Architectural Review Board

Meeting Minutes

September 11, 2017

**BOARD AND BRUSH CREATIVE STUDIO – SIGNAGE
CERTIFICATE OF APPROPRIATENESS**

Source: Front elevation along Market Street from submittal from Market Street Building Design

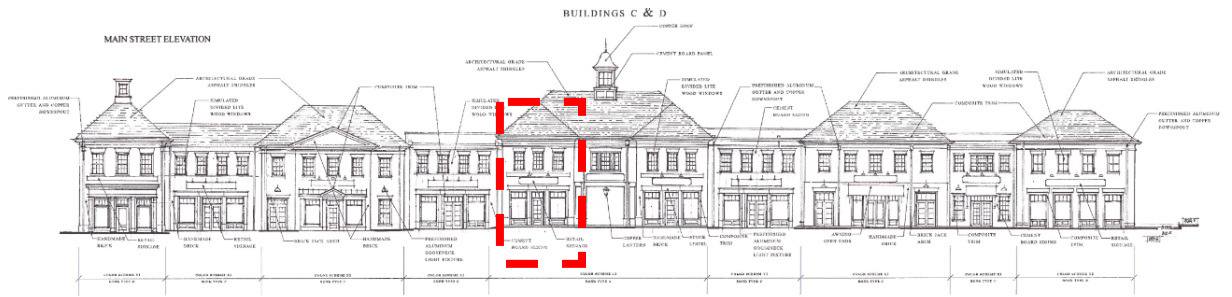
- The sign will read "Board& Brush creative studio"
 - The proposed sign board appears to be too small given the storefront and fascia size at the location.

- Although the proposed sign meets city code, the standard size of a wall sign in the Market Square area is 14' x 2' which is appropriately scaled to the building and design of the area. Staff recommends that the proposed sign be modified to 14' x 2' to match other existing signs in the area.

- Staff recommends the proposed sign have scalloped cove-cut corners and routed edges to match existing Market Square signage.
2. *The visual and functional components of the building and its site, including but not limited to landscape design and plant materials, lighting, vehicular and pedestrian circulation, and signage.*

1. The sign size will be 14’ x 24” to match existing signs at Market Square.
2. The sign will have scalloped cove-cut corners and routed edges to match existing signs at Market Square.
